Address: **5 BULLER STREET, NORTH PARRAMATTA**

Project: **PROPOSED BOARDING HOUSE DEVELOPMENT**

Report: **BCA REPORT FOR DA SUBMISSION**

Reference: 210348 – BCA Report

b. Proposed timber batten feature screen on Level 1 (SOU Bed 02 and Bed 03).

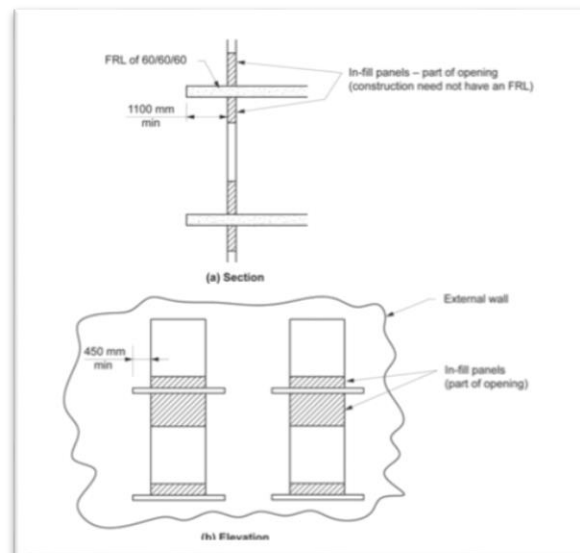
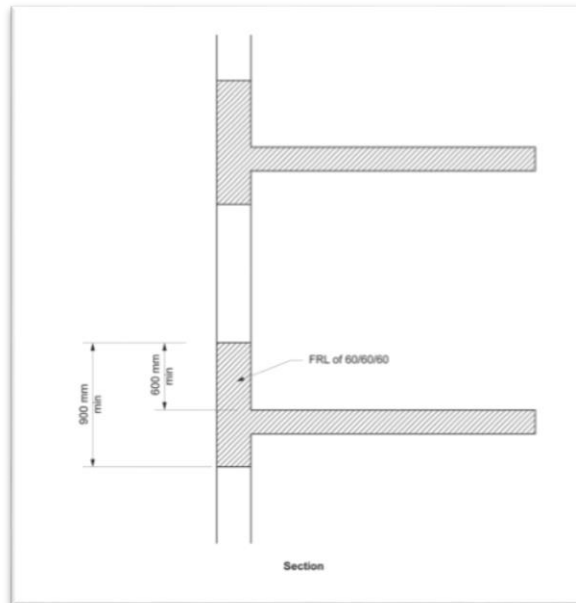
C1.11: Performance of External Walls in Fire	Not applicable	N/A
C1.13 Fire-protected timber: Concession	Not applicable	N/A
C1.14 Ancillary elements	<p>An ancillary element must not be fixed, installed or attached to the internal parts or external face of an external wall that is required to be non-combustible unless it is one of the following:</p> <ul style="list-style-type: none"> a) An ancillary element that is non-combustible. b) A gutter, downpipe or other plumbing fixture or fitting. c) A flashing. d) A grate or grille not more than 2 m² in area associated with a building service. e) An electrical switch, socket-outlet, cover plate or the like. f) A light fitting. g) A required sign. h) A sign other than one provided under (a) or (g) that— <ul style="list-style-type: none"> i. achieves a group number of 1 or 2; and ii. does not extend beyond one storey; and iii. does not extend beyond one fire compartment; and iv. is separated vertically from other signs permitted under (h) by at least 2 storeys. i) An awning, sunshade, canopy, blind or shading hood other than one provided under (a) that— <ul style="list-style-type: none"> i. meets the requirements of Table 4 of Specification C1.10 as for an internal element; and ii. serves a storey— <ul style="list-style-type: none"> A. at ground level; or B. immediately above a storey at ground level; and iii. does not serve an exit, where it would render the exit unusable in a fire. j) A part of a security, intercom or announcement system. k) Wiring. l) A paint, lacquer or a similar finish. m) A gasket, caulking, sealant or adhesive directly associated with (a) to (k). <p>Comment:</p> <p>Details of compliance are to be provided at CC Stage appointed certifying authority satisfaction.</p> <p>Your attention is drawn to the following areas which are required to be non-combustible:</p> <ul style="list-style-type: none"> a. Proposed Architectural Screening to perimeter of carpark area on Ground Floor 	<p>FI (CC Stage)</p>

C2.7: Separation by Fire Walls

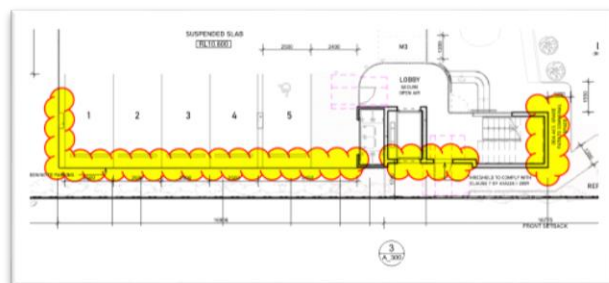
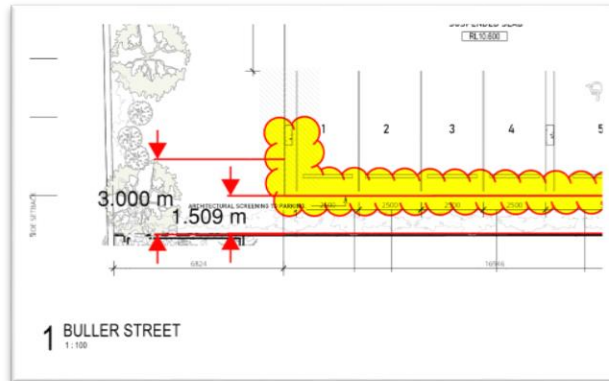
The fire wall has the relevant FRL prescribed by Specification C1.1 (Type A Construction) for each of the adjoining parts, and if these are different, the greater FRL.

Any openings in a fire wall must not reduce the FRL required by Specification C1.1 for the fire wall, except where permitted by the Deemed-to-Satisfy Provisions of Part C3.

SECTION C: FIRE RESISTANCE		
	<p>It is acknowledged that the following area is required to comprise of a firewall to separate between each applicable classification;</p> <p><u>i. Ground Floor (Carpark to Residential junction)</u></p>  <p>Note – It is the author opinion that the class 3 part of more than 10% of the floor area of the storey it is situated on.</p> <p><u>It is acknowledged that deemed-to-satisfy</u> solution may not be capable of being achieved and therefore Fire-Engineered Performance Solution is to be prepared by a C10 Accredited Fire Engineer at the Construction Certificate stage in order to justify the non-compliance and is to address the relevant Performance Requirements of the BCA accordingly.</p>	
C2.8: Separation of Classifications in the Same Storey	<p>Where applicable, fire-rated walls are to comply with this clause.</p> <p>If a building has parts of different classifications located alongside one another in the same storey -</p> <ol style="list-style-type: none"> each building element in that storey must have the higher FRL prescribed in Specification C1.1 for that element for the classifications concerned; or the parts must be separated in that storey by a fire wall having— <ol style="list-style-type: none"> the higher FRL prescribed in Table 3; or the FRL prescribed in Table 3, of Specification C1.1 as applicable, for that element for the Type of construction and the classifications concerned; or where one part is a carpark complying with Table 3.9, 4.2 or 5.2 of Specification C1.1, the parts may be separated by a fire wall complying with the appropriate Table. <p>Refer to clause C2.7 for identified firewall..</p>	<p>FI</p> <p>Coordination with consultants/stakeholders to be established</p>

PS
Refer to Part 5
of this report

Ground Floor

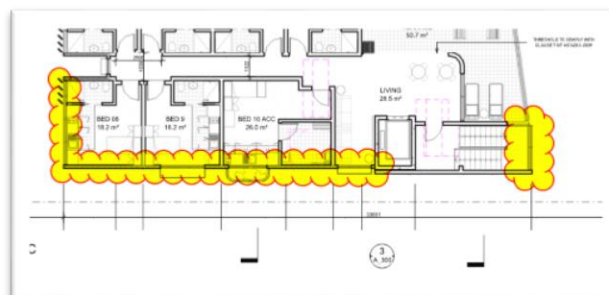
Should a deemed-to-satisfy solution ***not be proposed***, a Fire-Engineered Performance Solution is to be prepared by a C10 Accredited Fire Engineer at the Construction Certificate stage in order to justify the non-compliance and is to address the relevant Performance Requirements of the BCA accordingly.

C3.11: Bounding Construction: Class 2, 3 and 4 Buildings		<p>PS <i>Refer to part 5 of this Report</i></p>

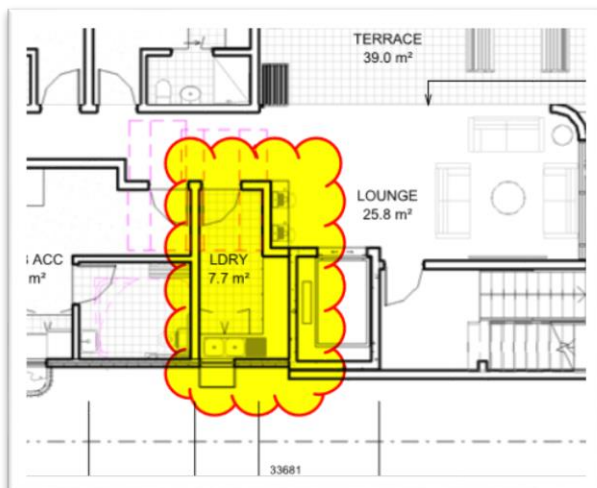
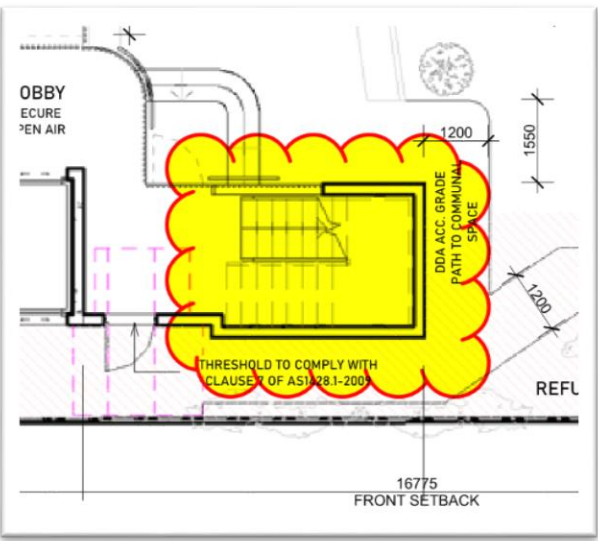
- b. “Living” area which is located on Level 1. Details of compliance are to be provided to the nominated PCA at CC stage.

It is the author opinion (unless advised otherwise) that the nominated “LDRY” room on Level 1 will be capable of achieving compliance with the requirements of this clause.

Should a deemed-to-satisfy solution not be proposed, a Fire-Engineered Performance Solution is to be prepared by a C10 Accredited Fire Engineer at the Construction Certificate stage

D1.4: Exit Travel Distances

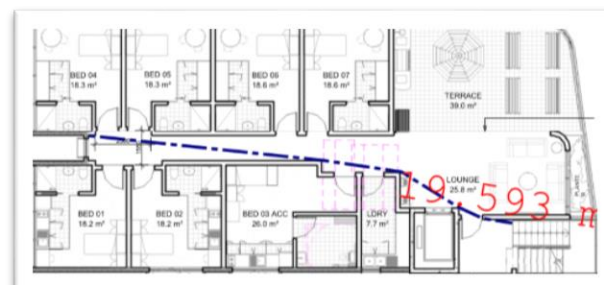
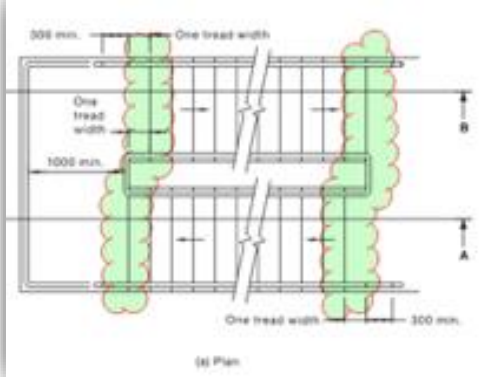
Your attention is drawn to the following areas based on desktop assessment;

- iii. **Ground Floor - The travel distance from this point of the floor will be approx. 23.522m (in lieu of 20m).**

- iv. **Level 1 - The travel distance from this point of the floor will be approx. 19.652m (in lieu of 6m).**

PS
Refer to Part 5
of this report
